**Re: Addendum to Water Resources and Water Demand Study (WRWD):
WRWD Summary Findings and Response to Stakeholder Comments and
Requests for Clarity**

1. THE PROPOSED HAIB MINE BY HAIB MINERALS NEAR NOORDOEWER, //KHARAS REGION, NAMIBIA
2. THE PROPOSED WATER ABSTRACTION AND SUPPLY INFRASTRUCTURE BY NAMIBIA WATER CORPORATION LTD (NAMWATER) TO SUPPORT THE HAIB MINE NEAR NOORDOEWER, //KHARAS REGION, NAMIBIA

Figure 1-1: The Orange, Senqu and Vaal River catchment and associated water management features.

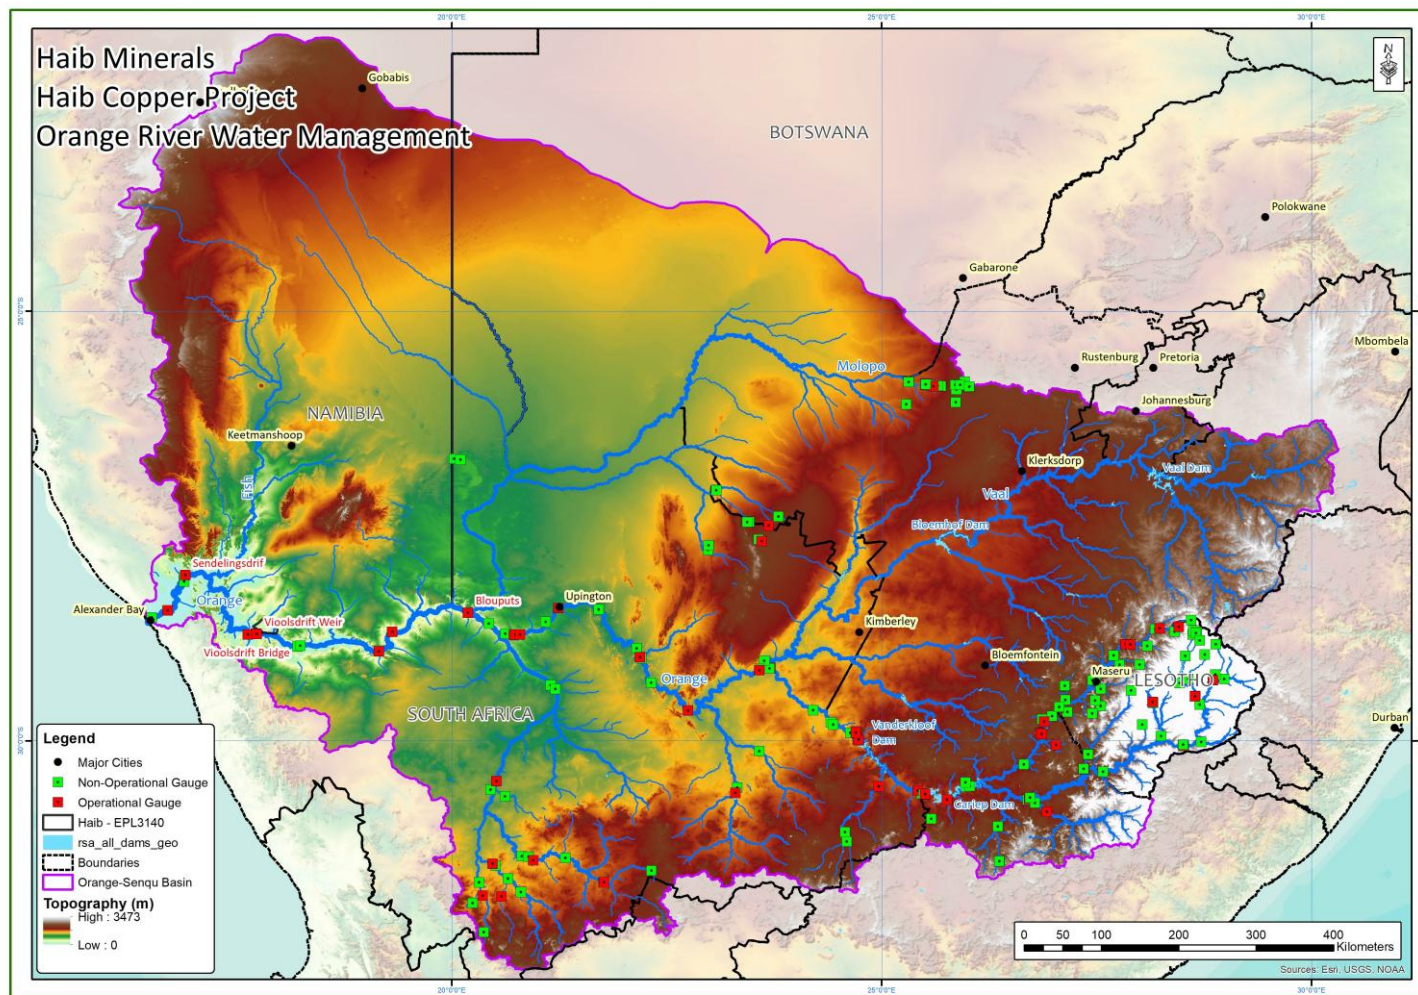
Could the team provide a map of the localities of the features described in the WRWD report	See Figure 1-1
Has Gariep Watch and Rosh Pinah been included as an I&AP?	The team has reached out to these stakeholders and included them in the database of registered I&APs.
Haib Minerals commissioned the WRWD study however NamWater are applying for the Water Abstraction License. How does this relationship work?	The development of the proposed Haib Mine by Haib Minerals requires a sustainable water source to support its operational and processing activities. NamWater intends to provide this service through the abstraction of water from the Orange River and conveyance to the off-channel water storage dam During the development of the Project, the identification of partnership opportunities between the, Haib Minerals and NamWater were identified. This coincided with the scoping phase of the EIA process. The

Figure 1-2: Observed average monthly flows by year at Blouputs and Sendelingsdrift gauging stations against various requirements in the lower Orange River System

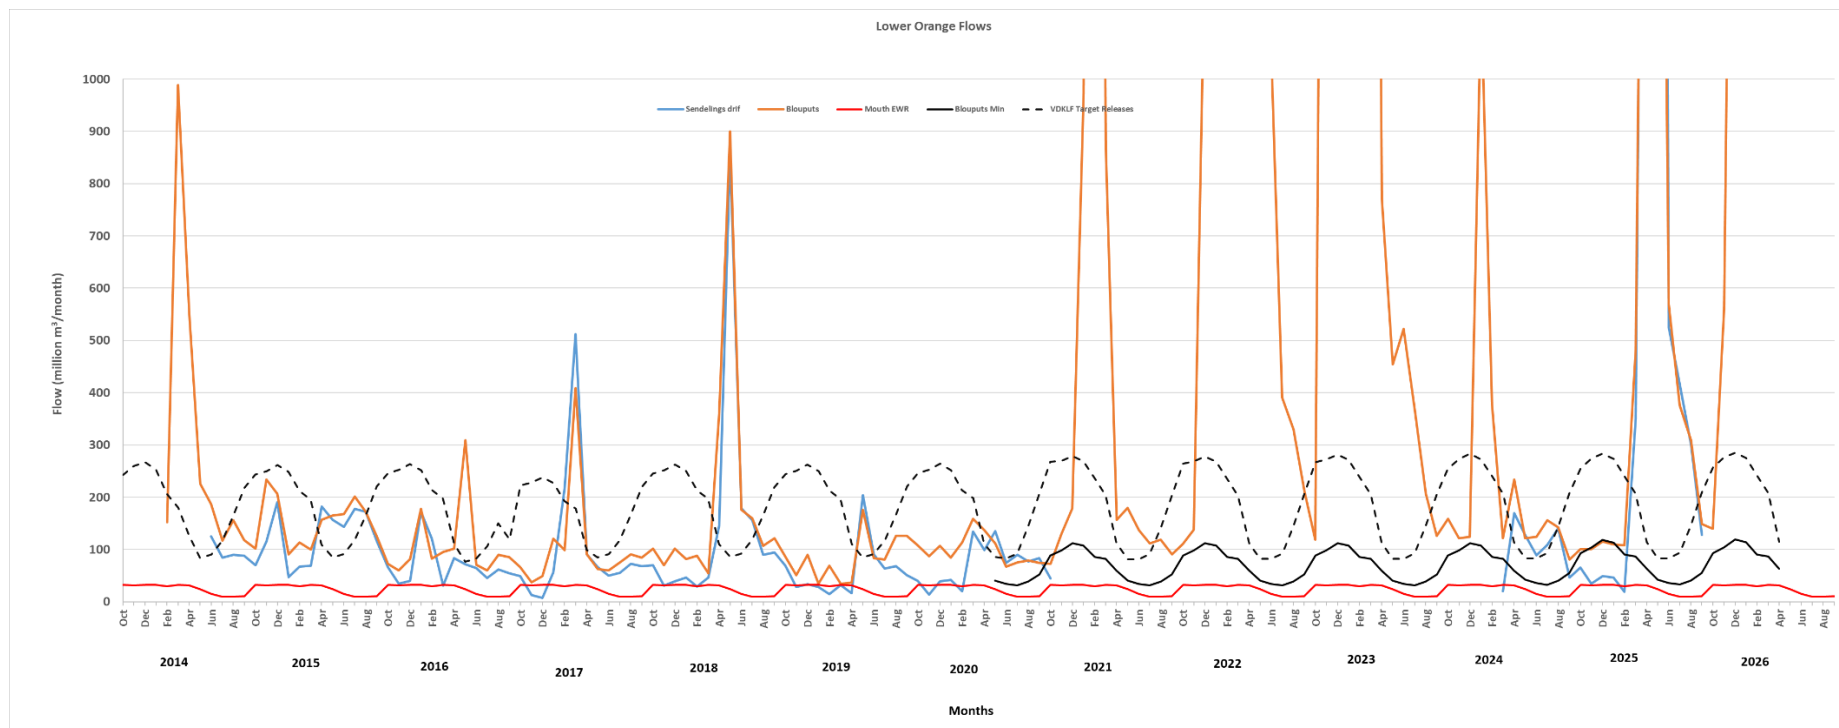
Did you look at plotting observed flow at Blouputs for just 2015-2016? (i.e. the worst years on record)	Plotting observed flows at Blouputs: Figure 1-2 shows observed flows plotted at Blouputs (orange). These low flows and those in 2019, as we understand, directly resulted in the minimum flows being implemented at Blouputs.
How can we understand the minimum flow further? Is it based on actual water rights issued by all countries, actual usage, estimates, etc? Is it ever reconciled with actual flow levels?	The water requirements are based on licences or allocations in combination with actual development where it is available. These are then all built into the model including the river losses of which evaporation is the largest component as and also including the environmental requirements as well as operating losses. An analysis with the model is then carried out to determine the minimum flows required at Blouputs that is needed to still be able to supply the downstream users, evaporation losses, operating losses and environmental requirements. These minimum flows are then adjusted to take into

Comment	Response
	account the lag time between Vanderkloof and Blouputs. These flows are used in the monitoring report prepared as part of the annual operating analysis. In the monitoring report the observed flow at Blouputs is on a weekly basis compared with the minimum flows. These comparisons, until now, has proven to relate well with the deficits experience in the lower Orange since the implementation of the minimum flows.
I know it is not your map but do you know why Vioolsdrift is not on the map for question 10 (page 15)?	This is unclear. The gauging station at the Vioolsdrift Bridge (D8H009) is active and data is available from 1979 to February 2026 (see comment above re data availability and processing). The gauging station at the Vioolsdrift Weir (D8H010) at the irrigation offtake is however closed and non-operational, with data available between 1958 and 1971.
Instead of using Blouputs as the minimum flow gauging point why are you not using Vioolsdrift (D8H009) since it is much closer. This will have a much better reflection of reality as we believe the consumption between Blouputs and Noordoewer can be substantially more than expected (especially in times of low flow and heat waves) Remember that it is perhaps 21 days of elapsed time from releasing water from the Vanderkloof to it arriving in Aussenkehr – i.e. releasing water when low flow is observed can still be very detrimental	Blouputs is used to measure the minimum flows and trigger upstream releases as it is more accurate than the gauging location at Vioolsdrift which is at the bridge, which is typically a less accurate measurement than at a dedicated gauging weir such as Blouputs. Minimum flows were already determined for Blouputs as part of the annual operating analysis and is used as one of the key points to check in the annual monitoring report of the Orange River System.
